8 May 2013

Re: SSD 5752, Sydney International Convention, Exhibition and Entertainment Precinct.

Figure 3 – Exhibition Tents on Event Deck

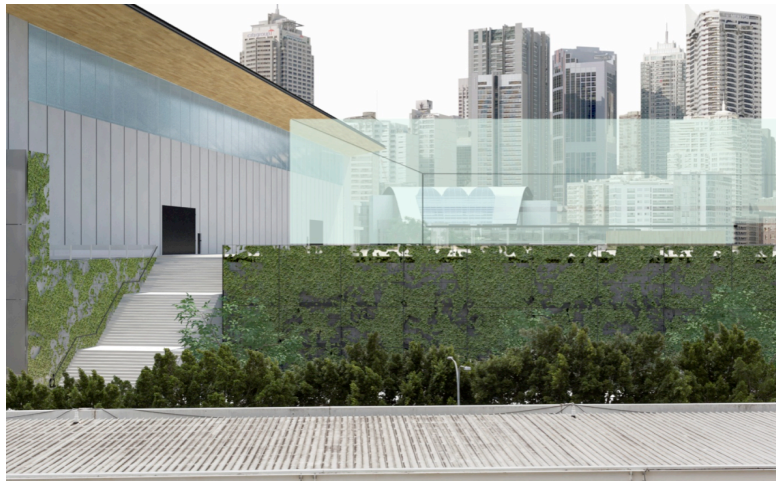
The current single story exhibition centre allows a 180-degree views from Ultimo of the city skyline. The only open space left from the proposal will be the section over the Event Deck, which allows only about 30-degree view from Bullecourt. Units from the ground floor of Bullecourt will lose virtually all views because the deck will be higher and nearer than the current roof. It is vital that the Event Deck remains an **open deck** as designed. The proposed 10 meters high exhibition tents over the deck (initially for 100 days annually) is an attempt to circumvent this (figure 3).

Figure 4 – Integrated Parkland

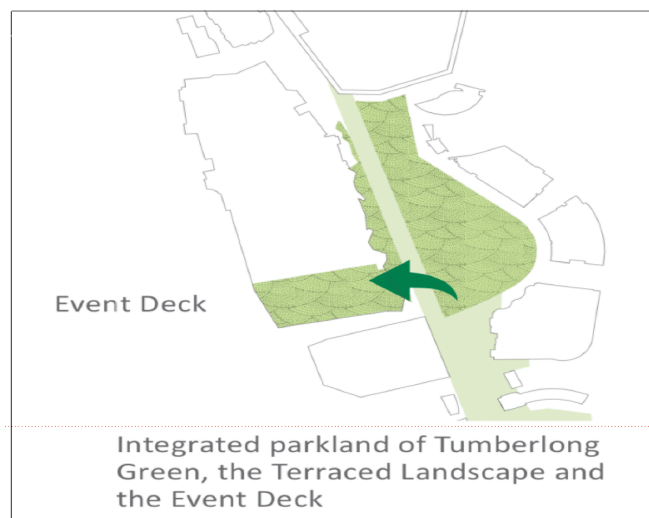
The proposed addition of 6 large apartments, hotels, and commercial premises (plus increasing new apartments around the vicinity) will reduce the open green spaces (green space per residents) in Darling Harbour. It is thus crucial that all proposed open spaces such as the Event Deck remain an open green space all year round. The Event Deck is promoted as an '**integrated parkland**' (figure 4) in the Public Realm Report 1-10 (pg.38).

Figure 5 – New Connecting Urban Grid

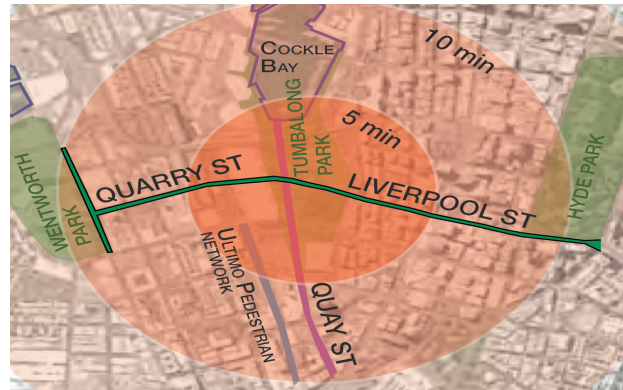
The Consultation Report (part 3, appendix 19, pg.11) described it as a **new connecting urban grid** linking Quarry St and Liverpool St (figure 5). It is Sydney's **Green Belt** from Royal Botanic Gardens, Hyde Park, Tumbalong Park, Wentworth Park, Blackwater Park, to Bicentennial Park. A **dedicated green landscaped space** is also clearly indicated in the alternative Multiplex proposal (figure 6).

Figure 8 – Top View

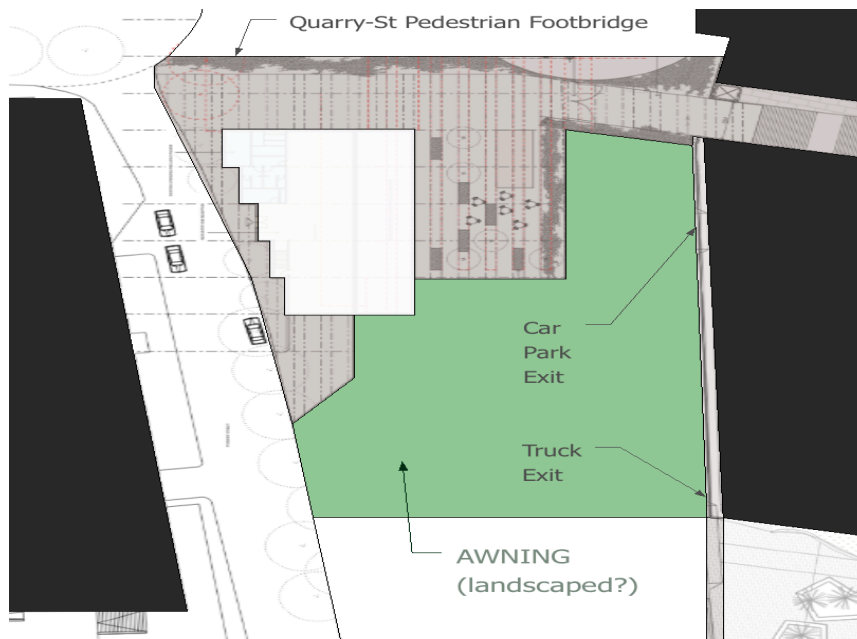
An inexpensive awning behind the event deck (figure 8-9) would reduce considerably noises coming from the car park exit, the truck exit, and from under the ramp. It is a win-win situation. Replicating the 'terraced landscape' to the western side would be a cost effective way of using an unused airspace (above the tramline/road eyesore), increase the area of the 'integrated parkland' (figure 4), provide a dedicated pass to Ultimo over the 'canyon' along Darling Drive, and reduce the problematic height of the buildings (Pymont Street is higher than Darling Drive).
